Access Compliance Report

Public Rights-of-Way

(Curb Ramps)

Intersection ID: 8828	Main Street: TODDVILLE_RD	Cross Street: URBANA_DR	Location:	S
ADA ID: 1A2222D363B8	Ramp Type: Perp	Initial Pass/Fail: Fail	Overall Compliance: No	Severity Score: 8.75

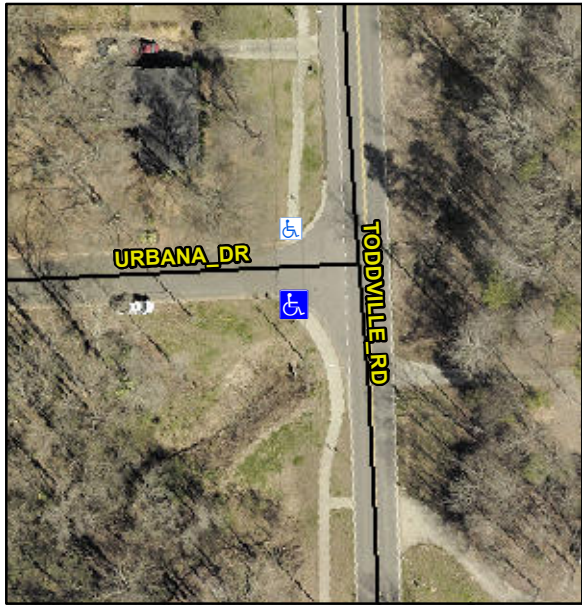
Codes/Mitigation Info/Possible Solution			Field Measurements/Component Compliance						
	Possible Solutions:		Compliance	Description	Data	Compliance	Description	Data	
	Remove & Replace Entire Ramp.		N/A	Ramp Length (in)	78.0	Yes	Ramp Slope (%)	5.2	
			No	Ramp Width (in)	47.0	Yes	Ramp XSlope (%)	1.7	
			N/A	Flare Type LT	N/A	N/A	Flare Type RT	N/A	
			N/A	Flare Slope LT (%)	N/A	N/A	Flare Slope RT (%)	N/A	
			N/A	Flare Traversable LT?	N/A	N/A	Flare Traversable RT?	N/A	
			N/A	Landing Length (in)	N/A	N/A	DWS Provided?	N/A	
			N/A	Landing Width (in)	N/A	N/A	DWS Contrast?	N/A	
			N/A	Landing Slope (%)	N/A	N/A	DWS Length (in)	N/A	
			N/A	Landing X Slope (%)	N/A	N/A	DWS Full Width?	N/A	
Surveyor Notes:	N/A		N/A	Landing Curb? (Y/N)	N/A	N/A	DWS Offset (in)	N/A	
			N/A	Shared Landing?	N/A				
	PROW/ADA:		N/A	Gutter Ponding?	N/A	N/A	Gutter Slope (%)	N/A	
	Not Found, R304.5.1		N/A	Gutter Lip Ht (in)	N/A	N/A	Gutter X Slope (%)	N/A

N/A	Painted X Walk1?	No	N/A	Painted X Walk2?	N/A	
				X Walk 1 Direction	To N		X Walk 2 Direction	N/A	
			N/A	X Walk 1 Width (in)	N/A	N/A	X Walk 2 Width (in)	N/A	
				X Walk 1 Slope (%)	6.2		X Walk 2 Slope (%)	N/A	
				X Walk 1 X Slope (%)	1.1		X Walk 2 X Slope (%)	N/A	
			N/A	Ramp inside XWalk1?	N/A	N/A	Ramp inside XWalk2?	N/A	
Street 1 Name	URBANA DR			Road Slope (%)	N/A	N/A	Clear Space?	N/A	
	Stop Condition-Street 2			Road X Slope (%)	N/A	N/A	Clear Space to XWalk (in)	N/A	
	Street 2 Name		N/A	N/A	Any Obstructions?	N/A	N/A	Storm Grate/Utility Hazard?	N/A
	Stop Condition-Street 1		N/A		Obstruction Type		Storm Grate/Utility Type		
						N/A		N/A	
						Yes	Surface Condition? (G/P)	Good	
Total Cost:			\$	1850.00
